Hearings Examiner Public Hearing - Hybrid (In-Person & Electronic) - Phase XII & XIII Preliminary Plat for Villages of Garrison Creek

10:00 AM. Phase XII & XIII Preliminary Plat for Villages of Garrison Creek - Public Hearing - Hybrid (In-Person & Electronic)

PRELIMINARY PLAT OF
VILLAGES OF GARRISON CREEK PHASES XII & XIII

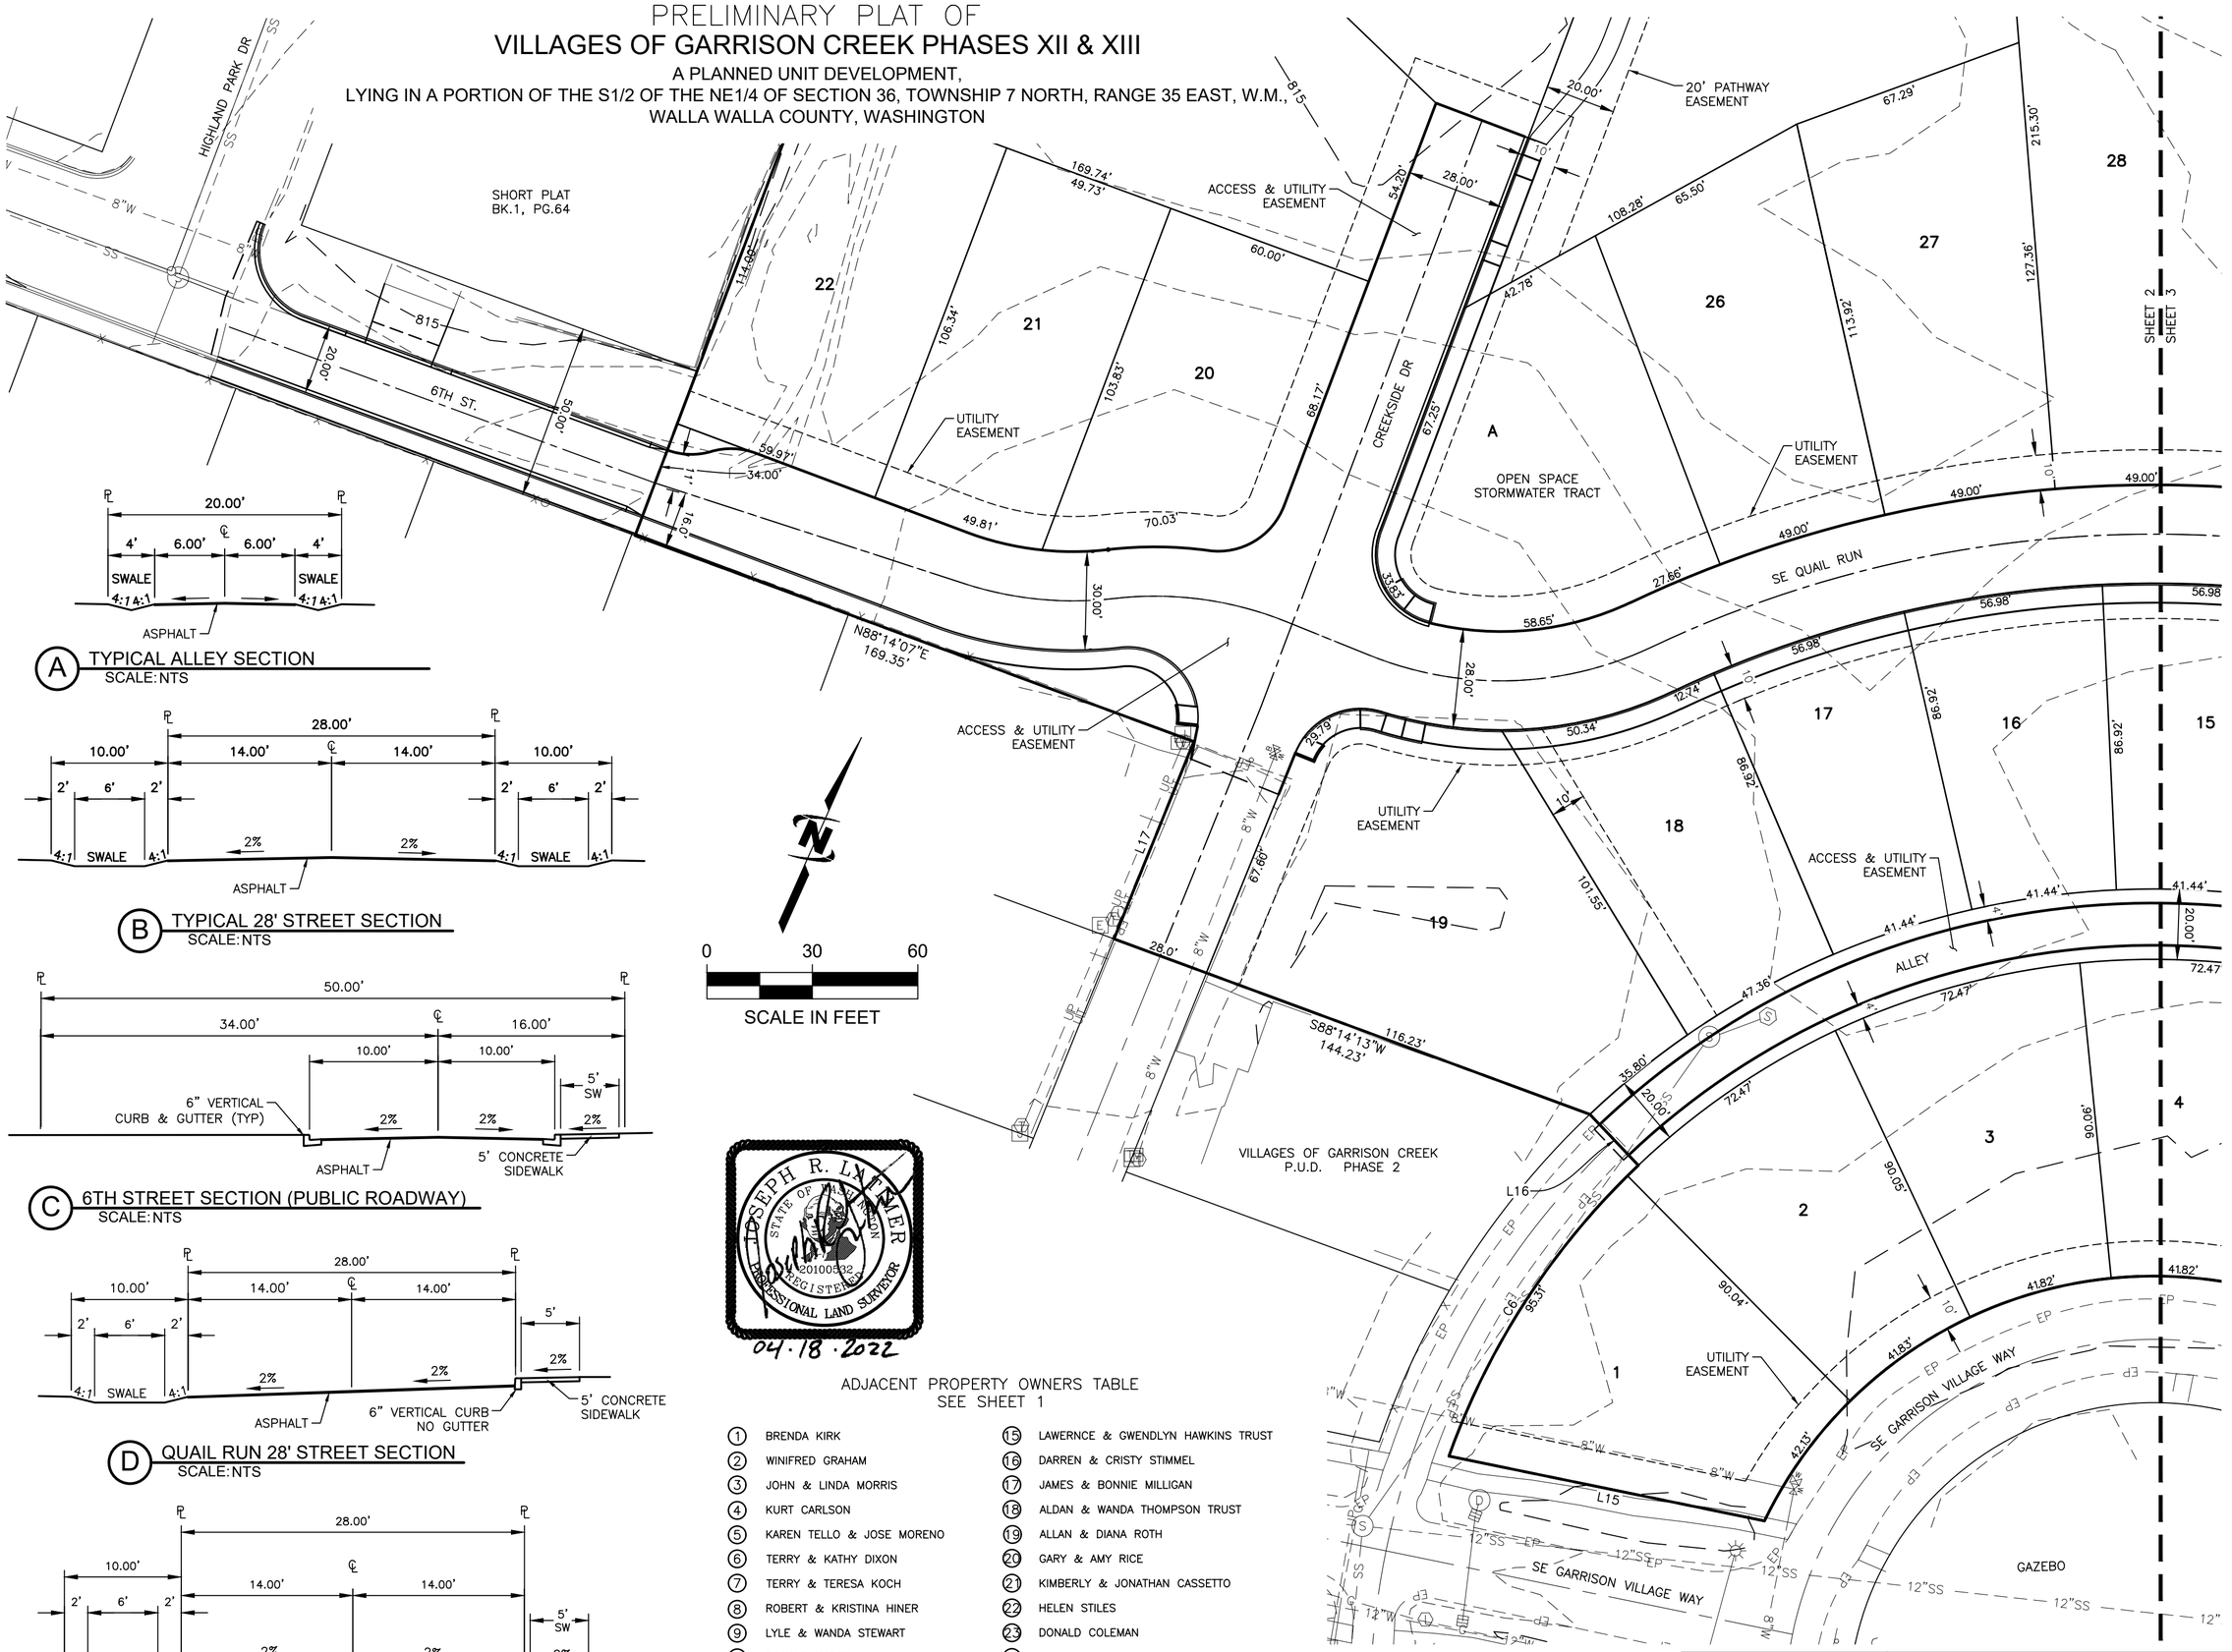
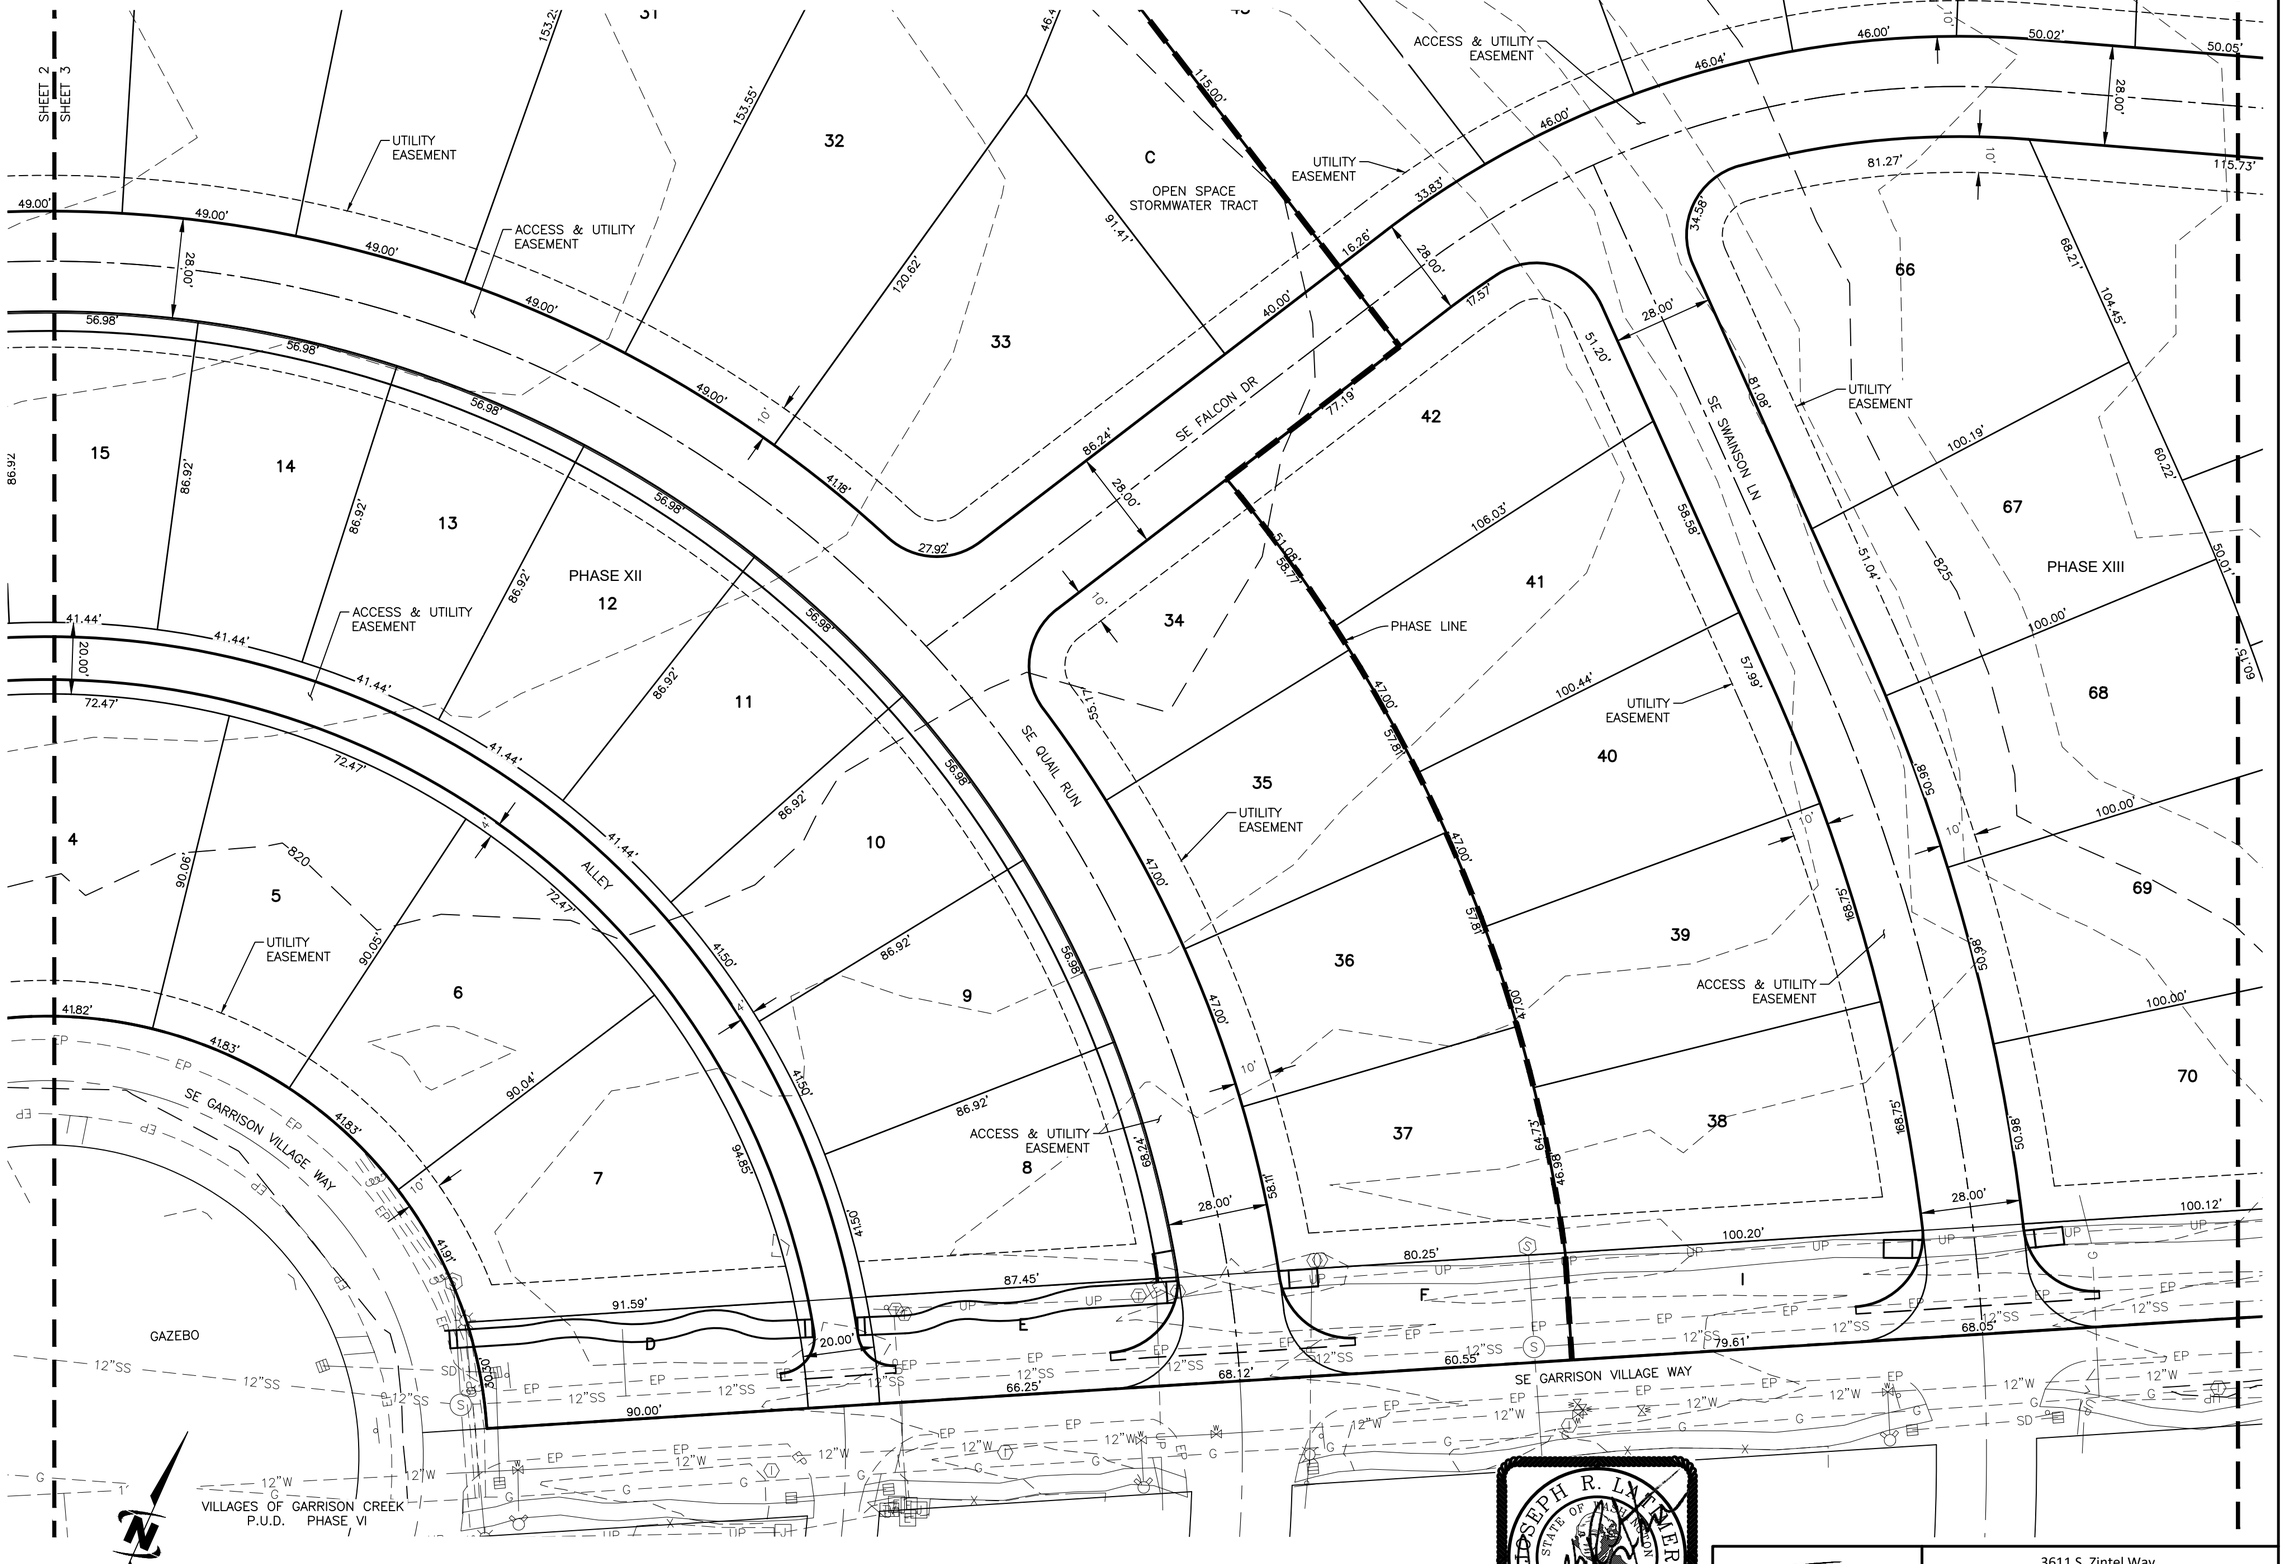
1. Together with the lot line dimensions that are shown, bearings and curve data need to be added to all the lot lines on the final plat. This may require additional curve and line tables.
